RE: **Lot 7 Block 5 Unit 18 SAD 228
8000 Compass Dr. NW
Volcano Cliffs Subdivision
Grading and Drainage Plan
Engineers Stamp Date 4/17/2022 (D10D003K7)**

Based upon the information provided in your submittal received 4/12/2022, this plan is approved for Grading Permit.

| ENGINEER'S SEAL DAVID SOULE NEW MEXICO 14522 REGISTERED PROFESSIONAL ENGINEER 4/17/22 DAVID SOULE P.E. #14522 | LOT 7 BLK 5 UN 18 VC 8000 COMPASS DR GRADING AND DRAINAGE PLAN  P.O. BOX 53924 ALBUQUERQUE, NM 87199 (505) 321-9099 | DRAWN BY DEM DATE 4-16-22 Lot 7 Blk 5 Un 18 VC.DWG SHEET # C1 JOB # |

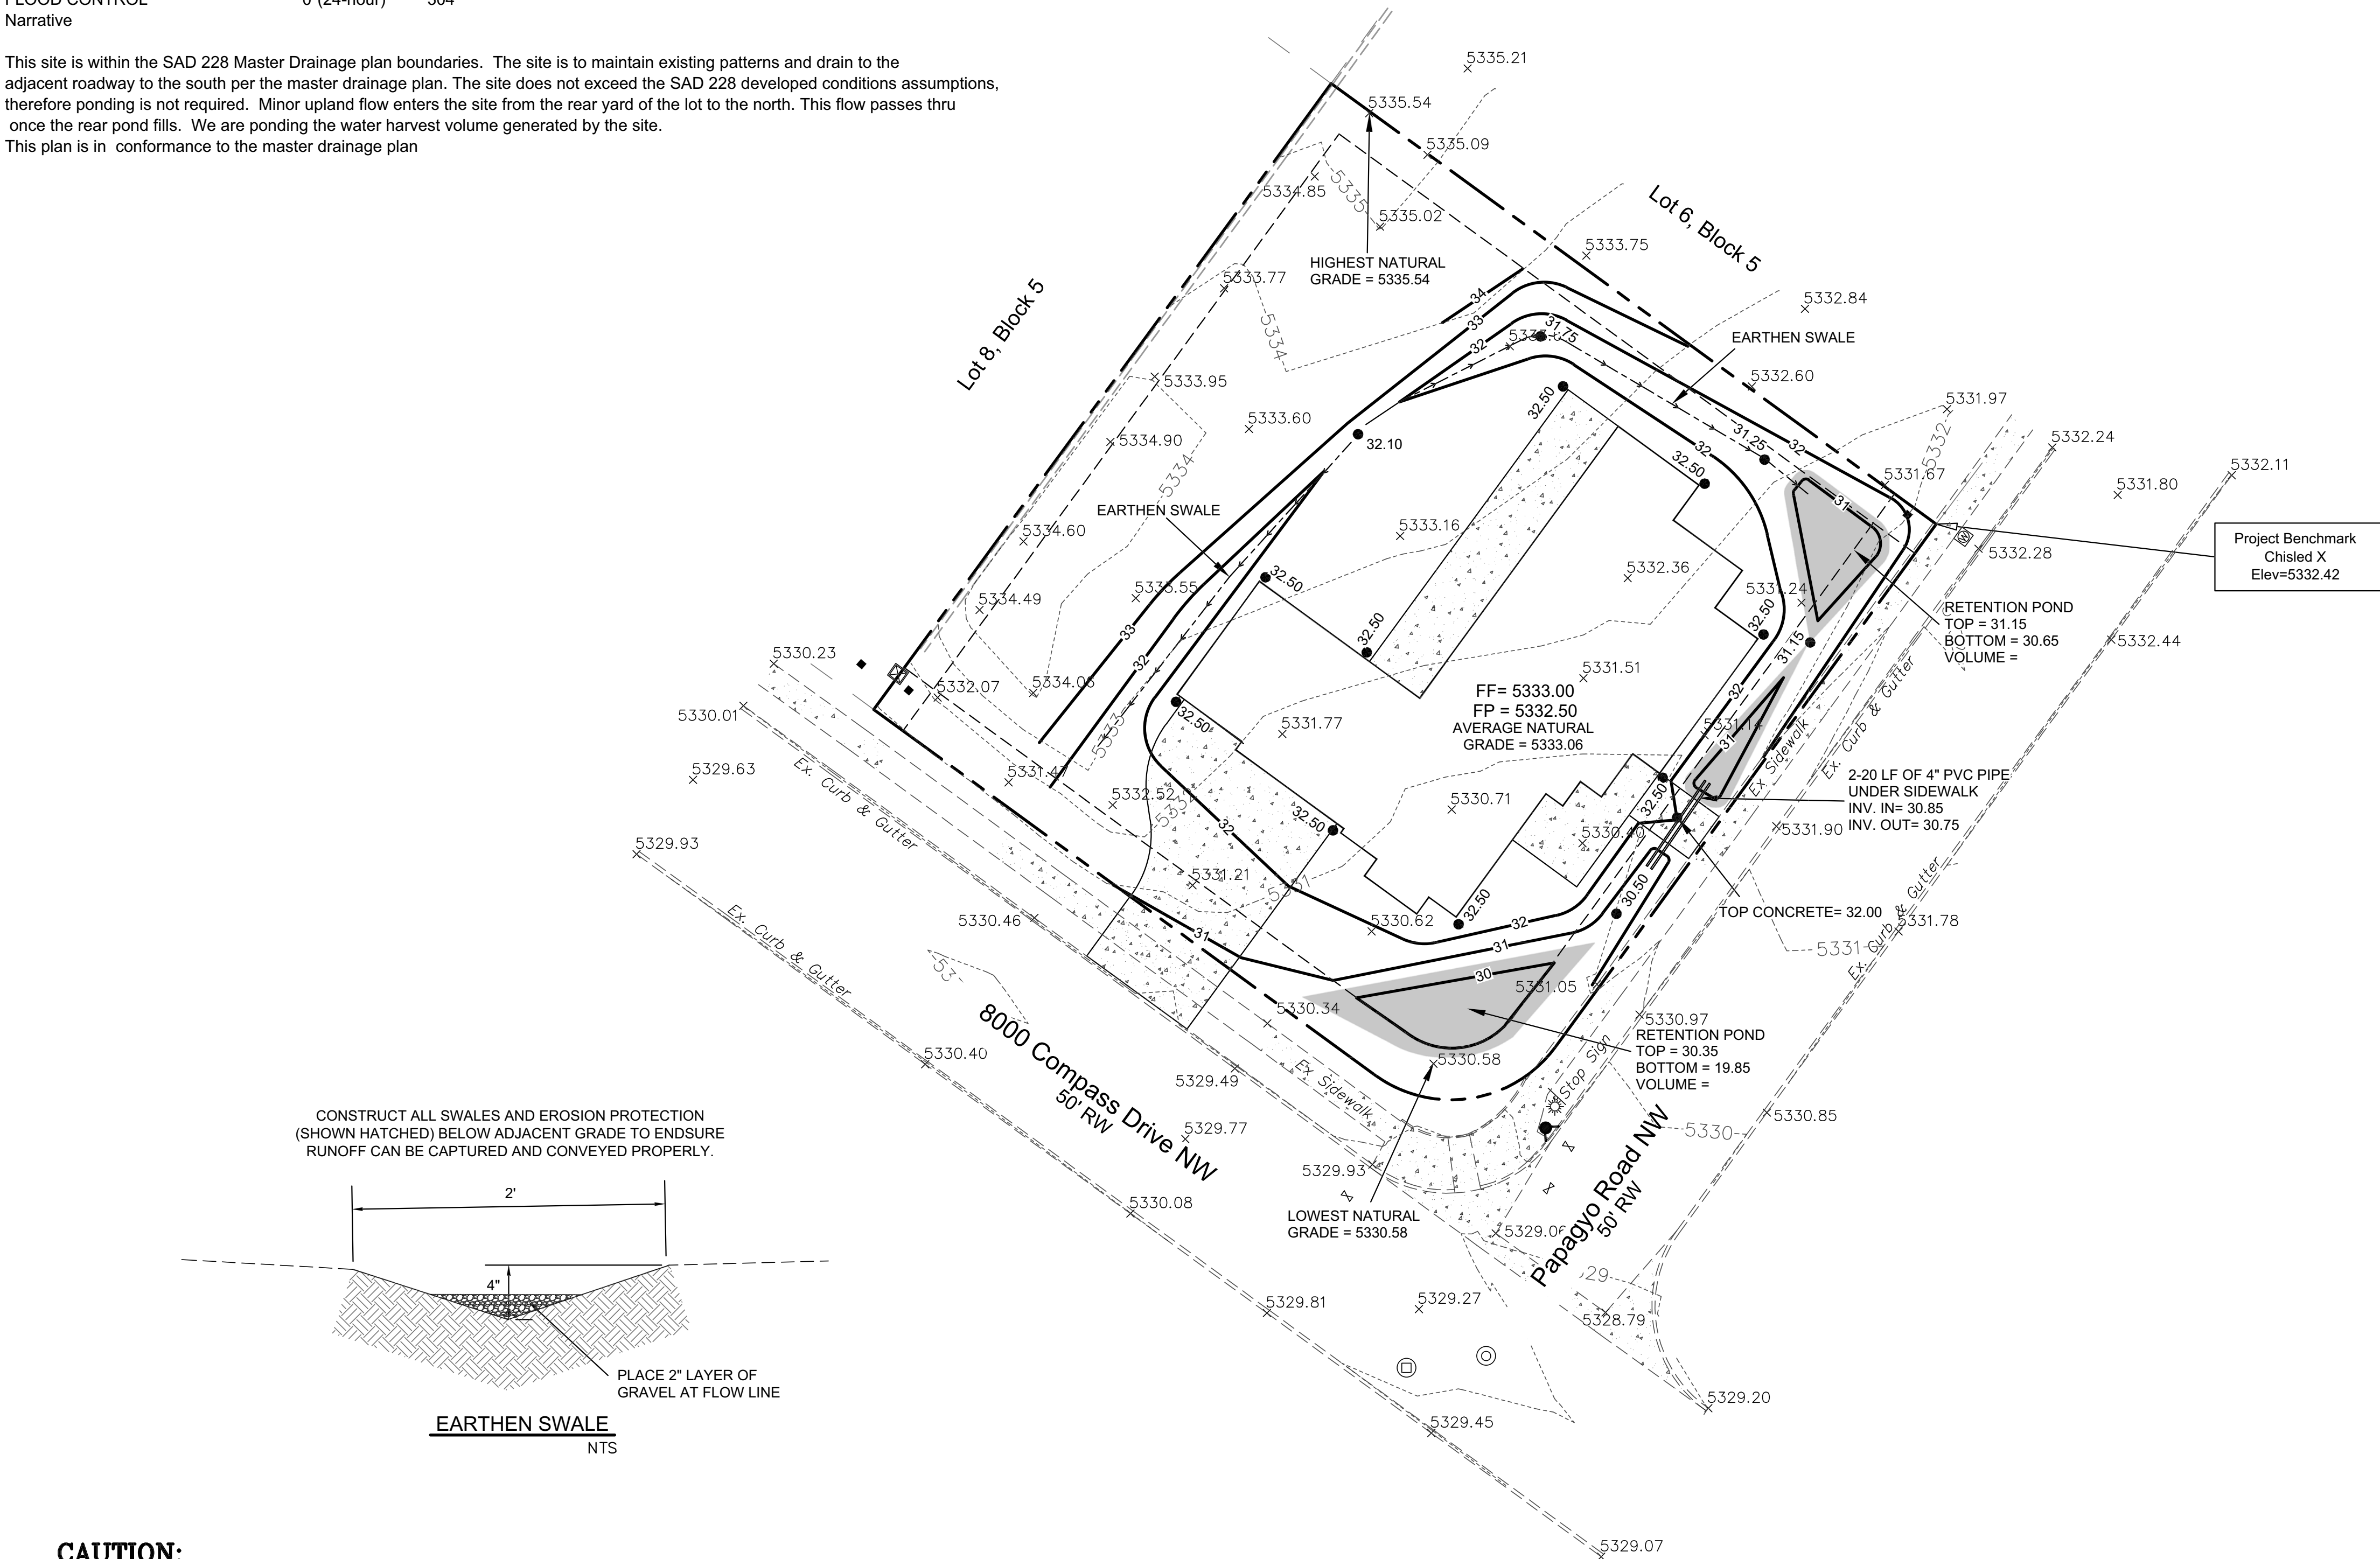
Prior to Building permit approval a Pad Certification will be required, provided by the Engineer or a registered Land Surveyor.

Advise the owner contractor not to use dirt as a ramp to climb the curb, use lumber or crusher fines for this purpose. Place this note on the plan.

Reiterate to the Owner/Contractor that a separate permit for a garden/retaining wall must be obtained with the approved G&D plan and Pad Certification. Also, if a swimming pool is to be placed after this approval a new grading and drainage plan will need to be resubmitted showing the changes for the land treatments.

Prior to Certificate of Occupancy release, Engineer Certification per the DPM checklist is required.
